TOWN OF BAY HARBOR ISLANDS
DEVELOPMENT & REVIEW COMMITTEE MEETING

1. Review and discussion of Site Plan Application by 1125 97TH Bay Harbor Condo 2618 LLC, to construct a 9-unit Multi-Family Development to be located at 1125 97 Street. Enclosed are the Site Plans and the Staff Report prepared by Town Planner Michael Miller.

**TOWN OF BAY HARBOR ISLANDS
COMMUNITY DEVELOPMENT
MEMORANDUM**

Subject: Site Development Plan Application – Formal Submittal
1125 97th Street - Multi-Family Residential Complex (9 DU)
Bay Harbor Islands Acct. No. SPR23-000028
MMPA Acct. No. 01-0702-1169

DECK GREEN AREA	
Name	Area
DECK	2649 SF
MEP	509 SF
	3158 SF
GREEN AREA	572 SF
	572 SF
	3730 SF

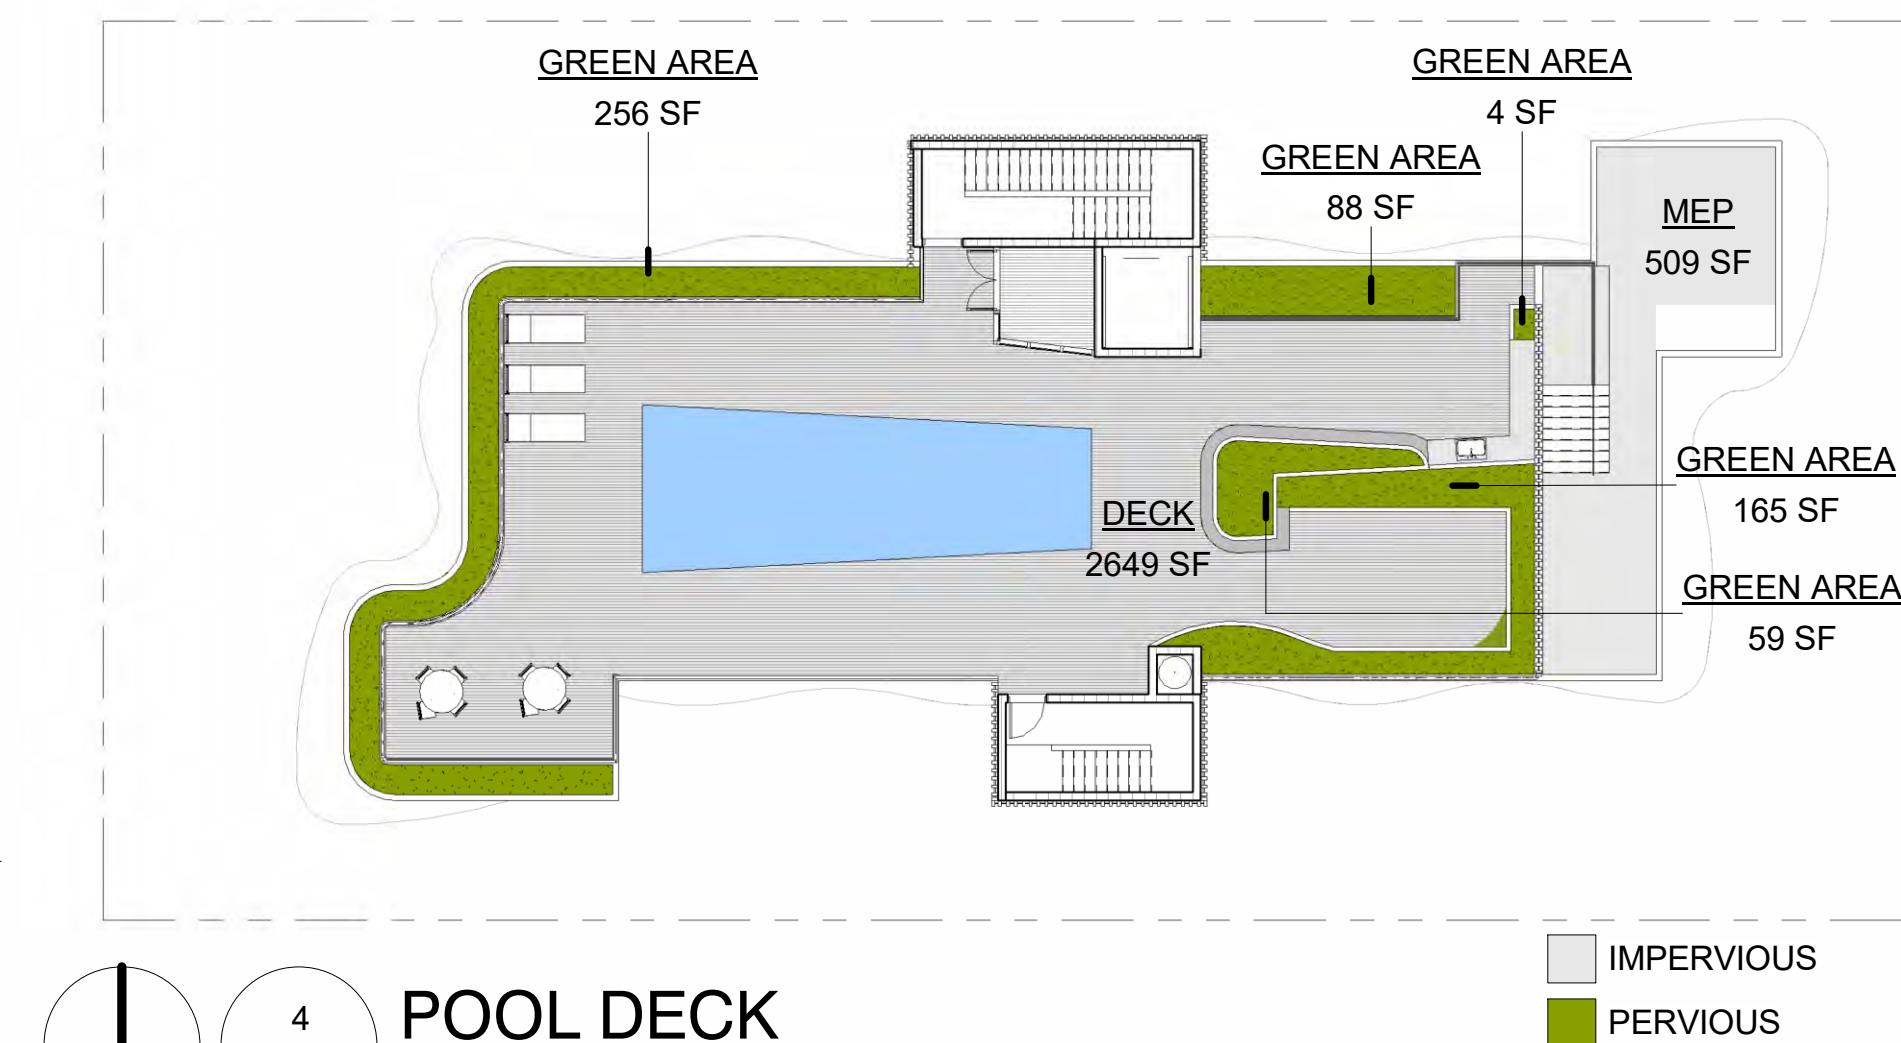
- 9) For the rooftop design a minimum of 15% of the roof area "used for recreation" must be landscaped. Sheet G004 Roof Deck detail lists the landscape area as 3,335 square feet. However, Sheet G003 Landscape Area at Roof LVL lists the area as 3,780 square feet. Please review and revise as required,

SITE PLAN

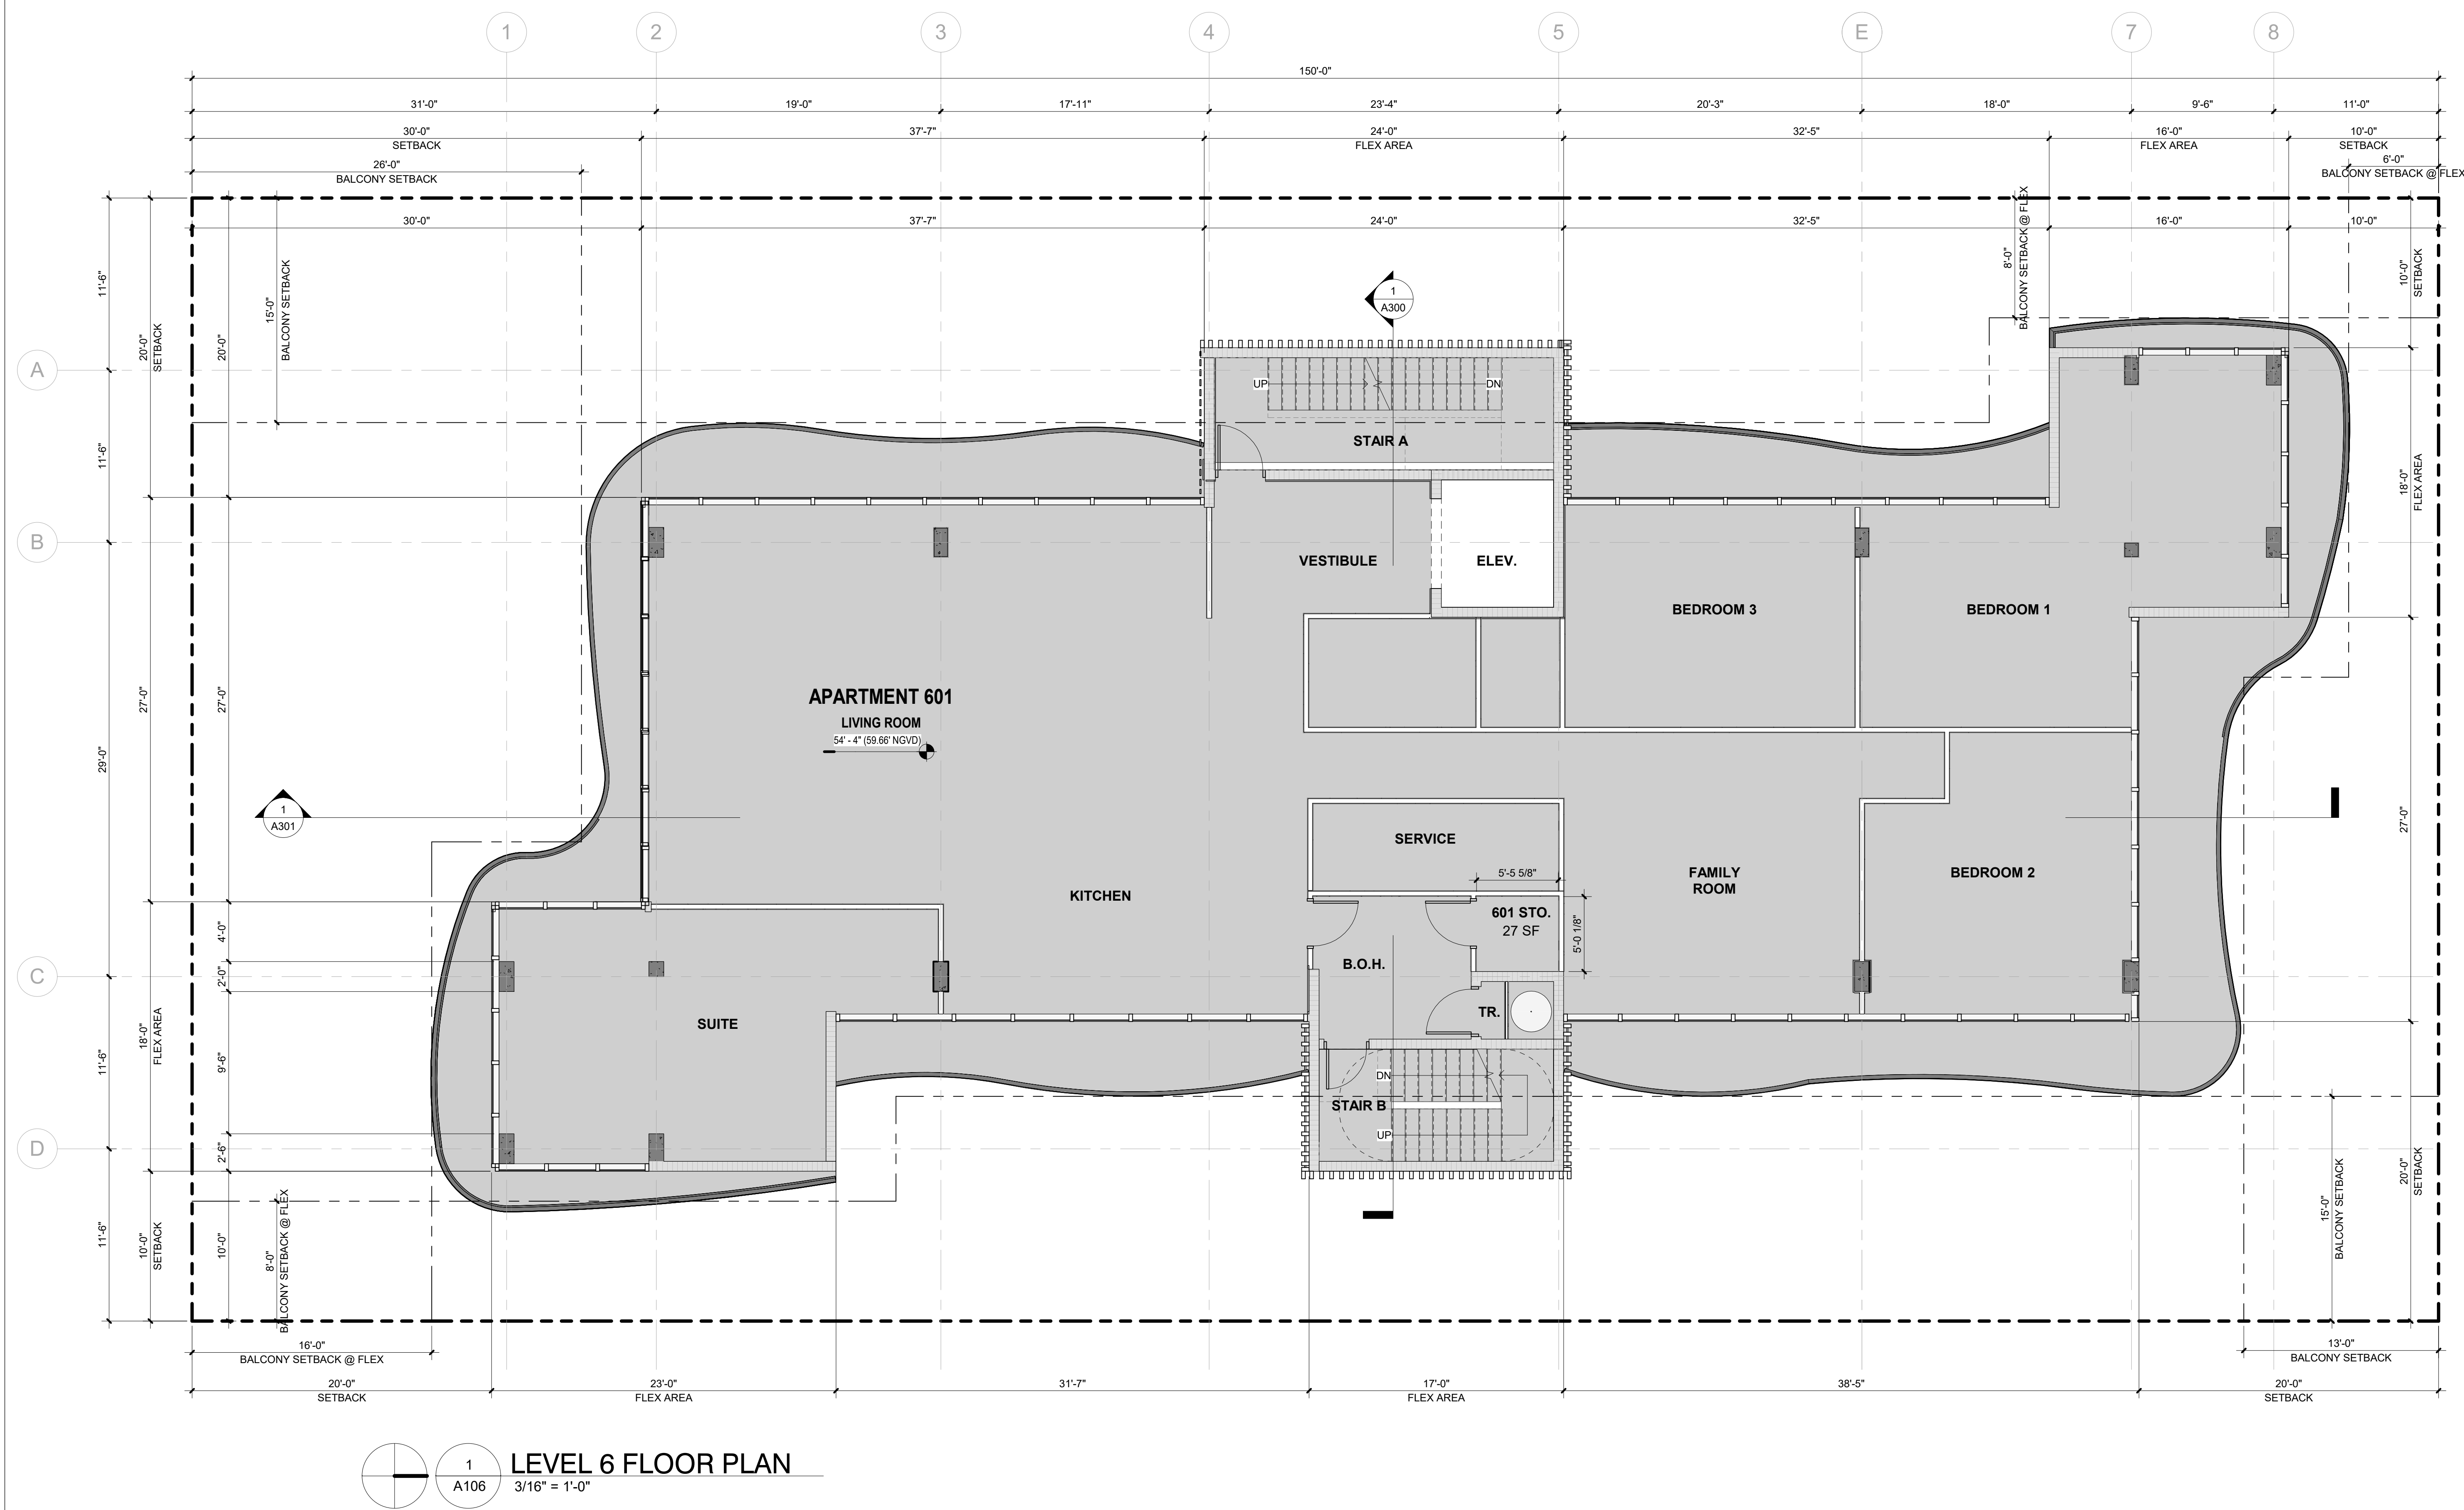
- 3) **Pedestrian Walkways** - The walkways in the east / west side yards may be no more than 5-feet in width (Sec. 23-12(15)(b)). The sidewalk on the west side is dimensioned 7' in some areas. Please revise to a max. of 5' width.

- 6) The plans show that the under-building parking spaces on the east side of the site will extend out from under the building - which is allowed - but screening is required (fence / wall and supplemental landscaping). The existing multifamily complex adjoining this site to the east faces Bay Harbor Terrace and the bedrooms of those units face west at this site - the parking must be screened (noise / glare / visual). The plans show only landscaping - a physical solid buffer is required (fence / wall) as stated at the Pre-DRC meeting.

A900

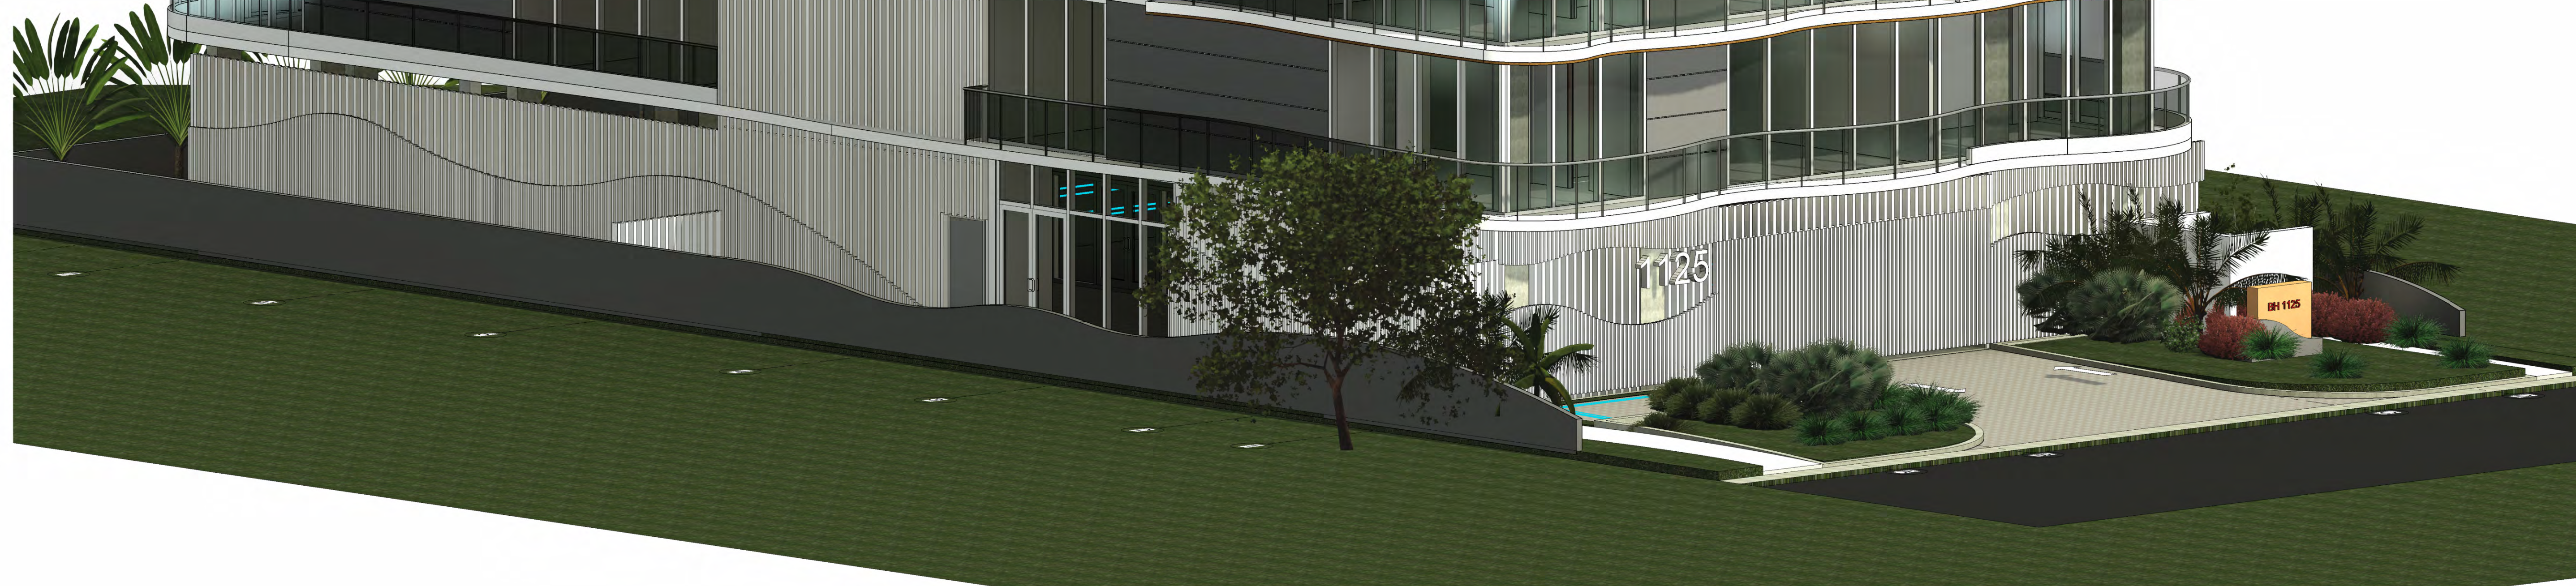
- 10) On the Building Elevation sheets the building height is shown measured from only FEMA BFE (8.0' NGVD) when the Town Code allowance is from existing FEMA BFE + 1' FBC Freeboard. Please clearly show the building height measured properly per the above.

BOUNDARY SURVEY 1125 97th STREET BAY HARBOR ISLAND, FL 33154		DATE: 03/14/2022	
SCALE: 1"=20'		SHEET 1	
OF 1 SHEETS			
No.	DATE	DESCRIPTION	
	6-14-23	UPDATE SURVEY	
BENNY SUAREZ SURVEYING INC. 4170 S.W. 152nd PATH, MIAMI, FLORIDA 33185 PH: (305)807-8319 Email: bennysuarez@msn.com

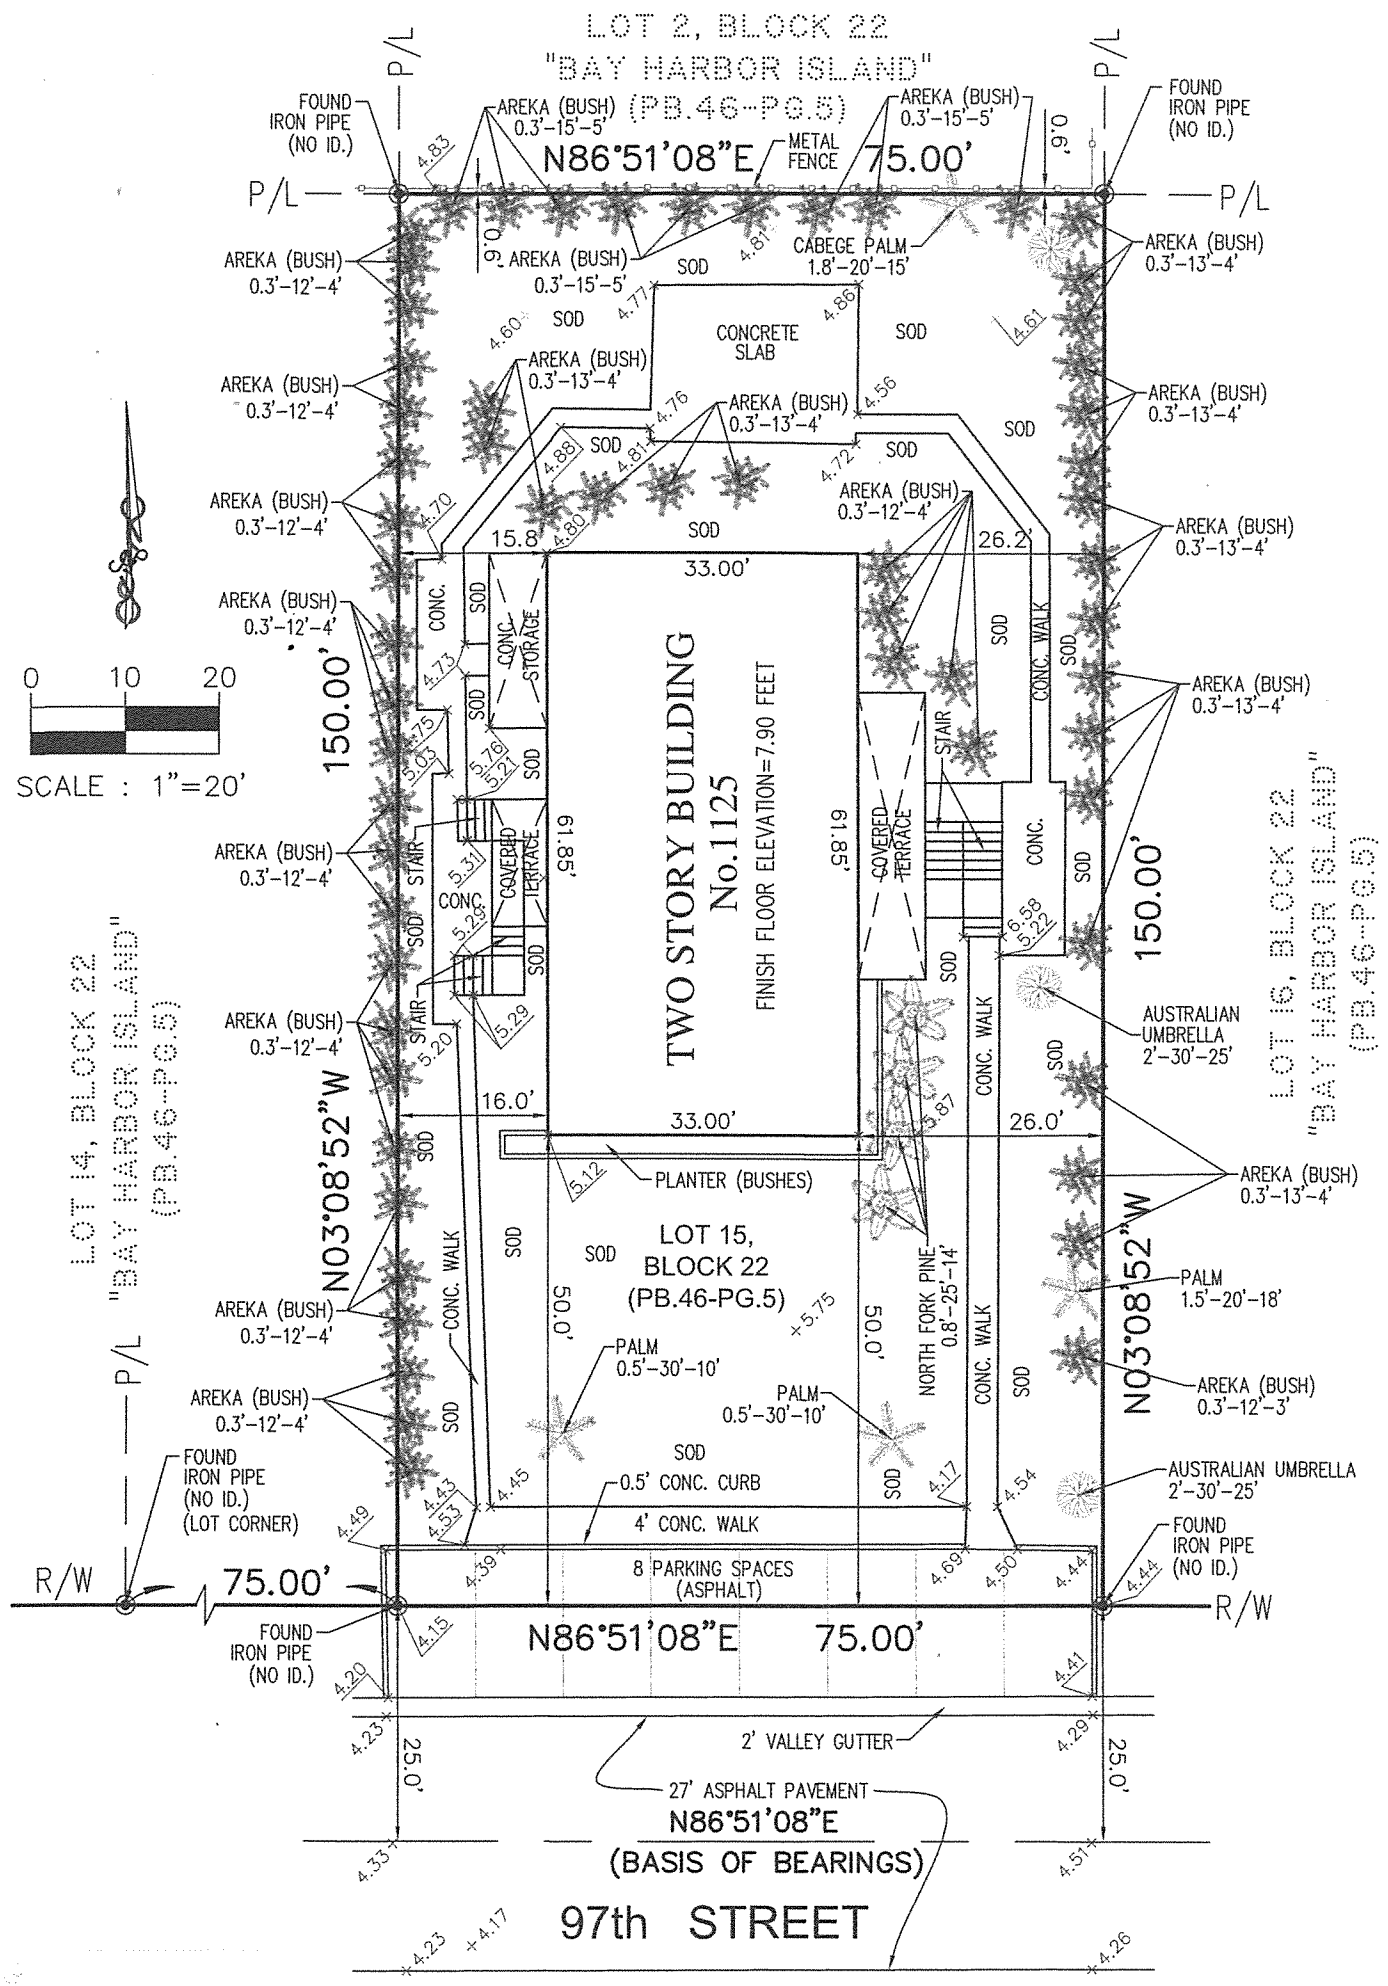
- 1) **Lot Area** - The lot area noted on Sheet G003 (11,250 square feet) does not match the lot area on the project survey 11,200 square feet. We feel this may be a survey typo / error. Please revise.
